114.8 Medium Dependent Interface (MDI)

114.8.1 MDI mechanical interface for 1000BASE-RHA

Figure 114–2—Duplex POF cable splitting and connection to the 1000BASE-RHA MDI receptacle

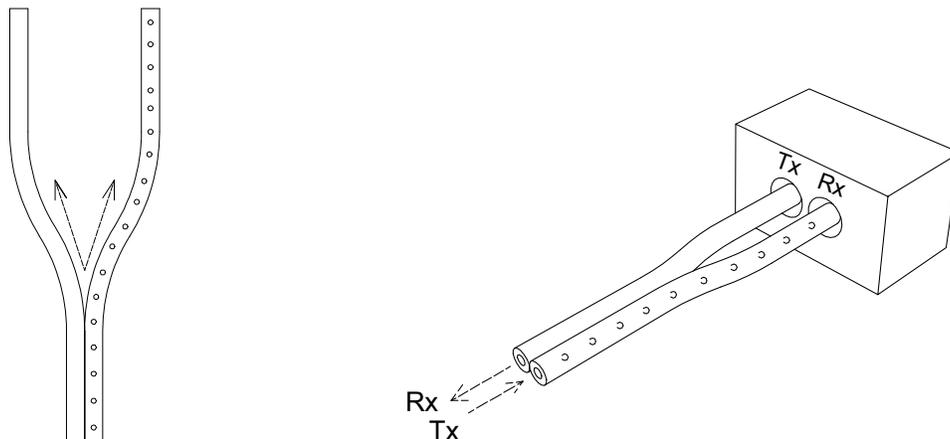
The POF cable ~~shall~~can be terminated without polishing by using a POF cutting tool (POF cutting tools are outside the scope of this specification). The termination tool may clamp the POF cable (without damaging the fibers) to prevent movement when cutting it (e.g., with a razor blade). The termination process shall provide a cable compliant with the following specifications:

- The resultant fiber end facets are perpendicular to the cable axis with ~~a maximum end angle error of less than~~ $\pm 5^\circ$.
- The flatness of the fiber end facet has an insertion loss of less than 1.5 dB, per butt coupling of two resultant segments after termination.

The duplex cable splitting ~~shall~~should have sufficient length to ensure:

The 1000BASE-RHA MDI receptacle connector vendor shall properly~~clearly~~ indicate the minimum split length needed for a suitable connection. Left side of Figure 114–2 illustrates the duplex POF cable splitting and the right side the fiber cable connection to 1000BASE-RHA MDI receptacle.
